# Service Bulletin

## PRELIMINARY INFORMATION

**Subject:** Exhaust Leak and/or Service Vehicle Soon (SVS) On and DTC P0171 Set

**Models:** 2013 Chevrolet Cruze, Sonic  
2013 Chevrolet Trax (Canada Only)  
Equipped with 1.4L Engine (RPO LUV)

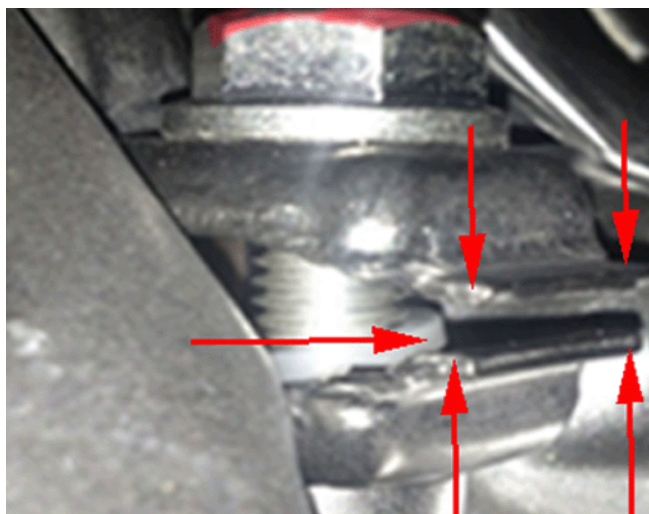
Some customers may comment on a exhaust leak type noise and/or the service vehicle soon (SVS) light on.

A DTC P0171 may be stored in history.

This condition may be caused by excessive amount of glue used by the supplier to retain the gasket before mounting the converter to the manifold. Hardened glue may have filled the sealing gap, which restricts the V-band clamp to draw both flanges together completely.

Inspect the exhaust V-band clamp to ensure that the ends are completely closed with no gap. If the ends of the V-band clamp show to have a gap present, follow the procedure below. If the ends of the V-band clamp have no gap between them, follow further diagnosis in SI.

**Note:** The illustration above shows the ends of the V-band clamp with the gap.

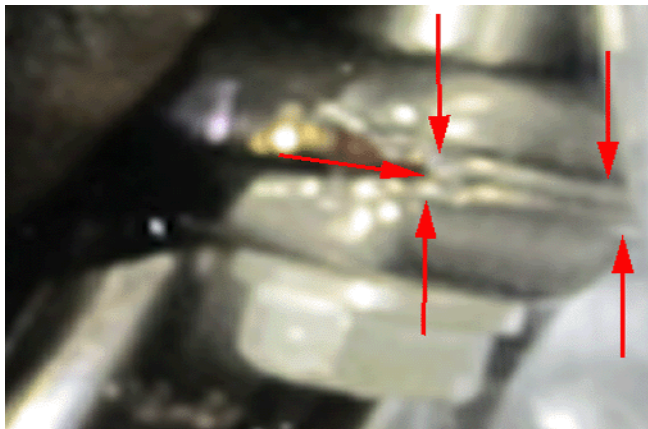
**Note:** The illustrations above show the ends of the V-band clamp with both flanges together completely.

**Important:** While performing this procedure, **DO NOT** loosen the two fasteners that restrain the converter onto the engine. This would risk damage to the gasket due to separation of the flanges and repositioning.

2. Unscrew the fastener on the V-band clamp a total of several rotations.
3. Using a screwdriver, pry the clamp apart and make sure that both halves of the clamp are loose and not stuck to either flange.
4. Tighten the bolt.

**Tighten:** Tighten the bolt to 13 Y (115 lb in).
